From: Richard West
Sent: 18/10/2023 7:03:47 PM
To: Scott Phillips; Councillors; Louise Kerr; Andrew Johnston; Trish Chaney;
ElectorateOffice Pittwater; Scamp Sophie
Subject: TRIMMED: Objection letter - 1112-1116 Barrenjoey Road Palm Beach -
DA2023.1289.pdf
Attachments: Objection letter - 1112-1116 Barrenjoey Road Palm Beach -
DA2023 1289 pdf;

**Submission with regard to Development Application DA2023/1289
Demolition works and construction of Shop Top Housing
1112-1116 Barrenjoey Road, Palm Beach, NSW**

Figure 3 - 8.5 m height plane breach – note the scale of adjacent development along the Barrenjoey Road and the direct correlation with where the height breach starts to occur.

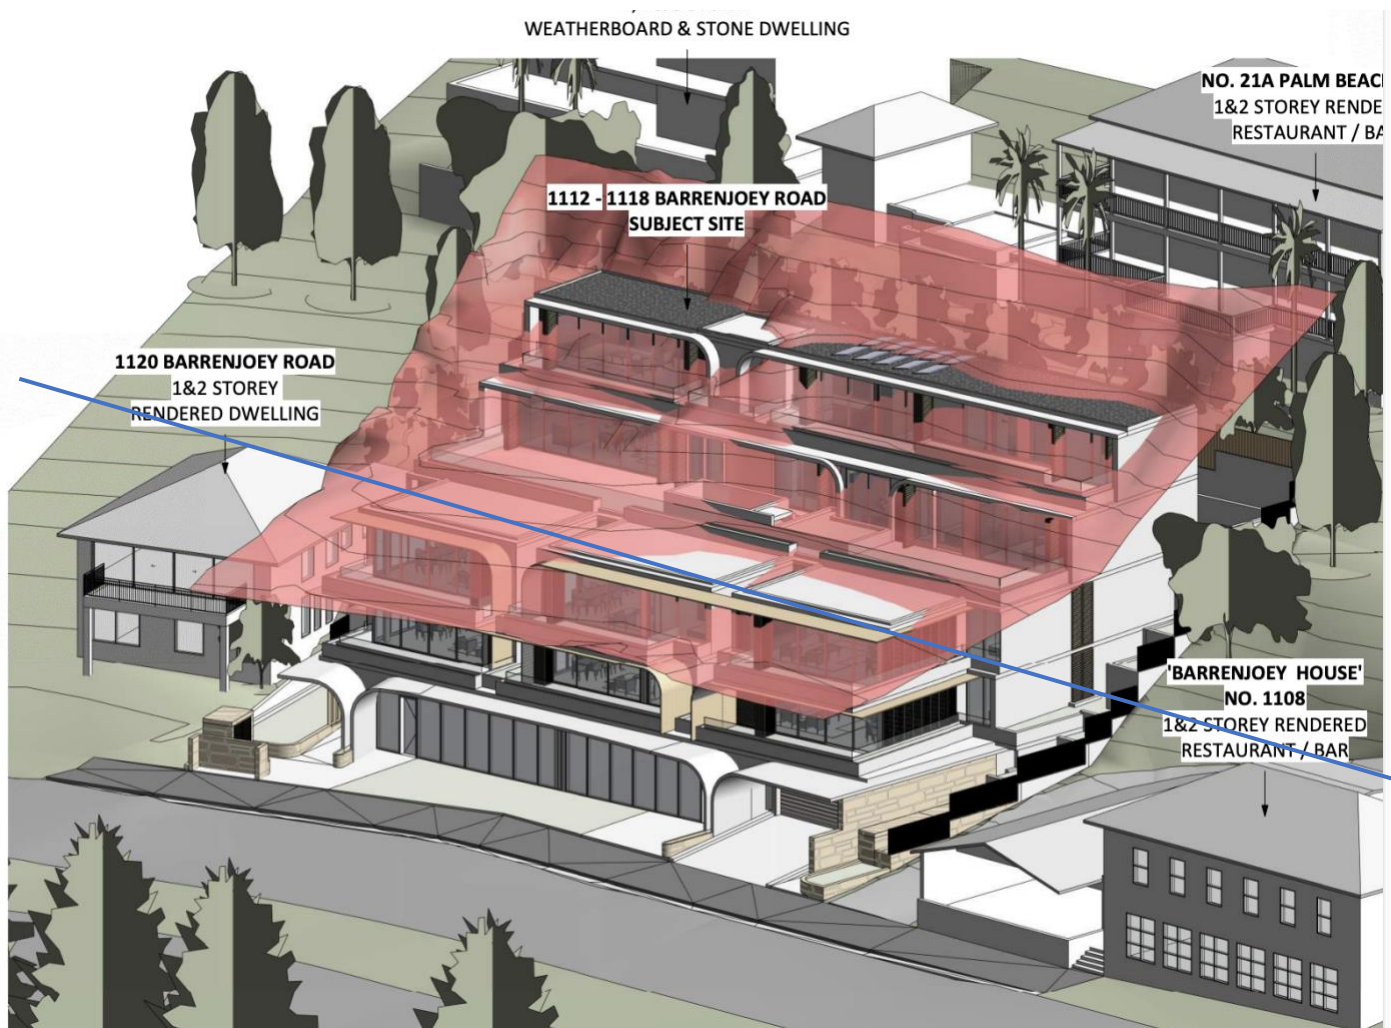
Comment: The proposed development fails to meet this objective, as already detailed in this objection and as shown in figures 3 and 4.

Clause 4.3 (2D) (a) - The height breach cannot be considered as minor. The submitted height plane diagrams demonstrate a breach of the maximum height limit at 3 of the 5 levels proposed (levels 2, 3 and 4). The top two levels have been recessed into the site and overhang the rear setback in an attempt to reduce the breach and give rise to additional impact on neighbouring amenity, visual impacts and building separation distances. A breach of the maximum height of buildings across 3 of 5 levels of a development cannot be considered as minor.

- Remove levels 3 and 4 from the proposed development and strictly comply with the 8.5 metre height limit.
 - Pull back the rear and side elevations of the proposed development to strictly comply with the ADG. 6-12 metre building separation distances are required.
